From: Brian.Davidson@dot.ohio.gov
Sent: Friday, August 4, 2023 9:52 AM
To: Matthew B. Rehfus, P.E., S.I.
Subject: FW: Alum Creek Drive - Feasibility Study - FRA-CR122-0.00 - PID 115792
Attachments: pid115792-FRA-CR122FS_Comments.csv; RE: Alum Creek Drive - Feasibility Study - FRA-CR122-0.00 - PID 115792; RE: Alum Creek Drive - Feasibility Study - FRA-CR122-0.00 - PID 115792; RE: Alum Creek Drive - Feasibility Study - FRA-CR122-0.00 - PID 115792; RE: Alum Creek Drive - Feasibility Study - FRA-CR122-0.00 - PID 115792; RE: Alum Creek Drive - Feasibility Study - FRA-CR122-0.00 - PID 115792; RE: Alum Creek Drive - Feasibility Study - FRA-CR122-0.00 - PID 115792

FRA-CR122-0.00 (PID 115792) – Feasibility Study

Subject: Feasibility Study Review – Franklin County Engineer’s Local-let project reconstruct and widen Alum Creek Drive from Groveport Road to State Route 317. This project has TRAC and MORPC federal funds and is anticipated to award in FY28.

Figure 1

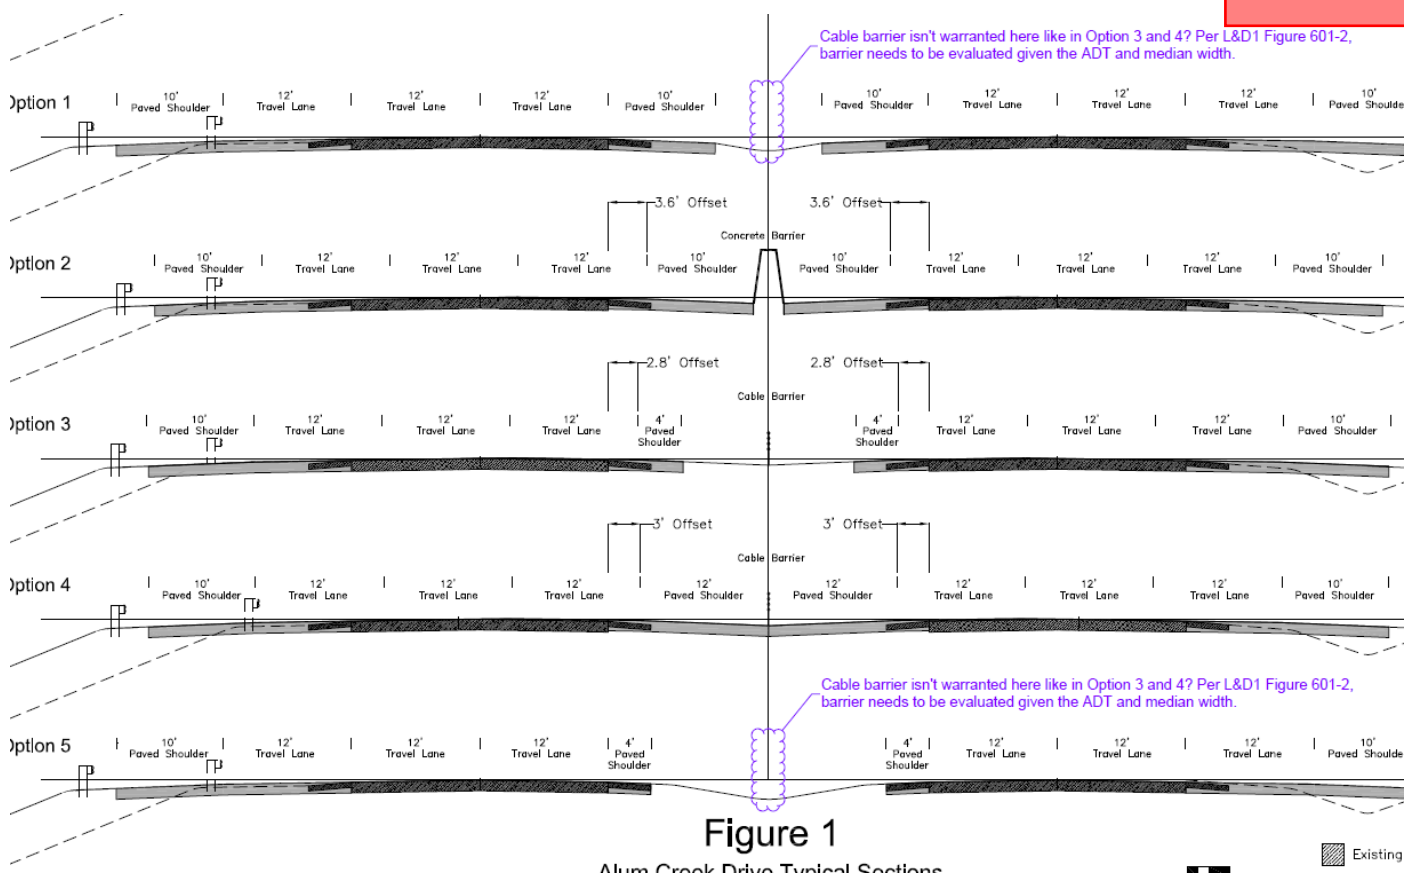
This alternative has been removed.
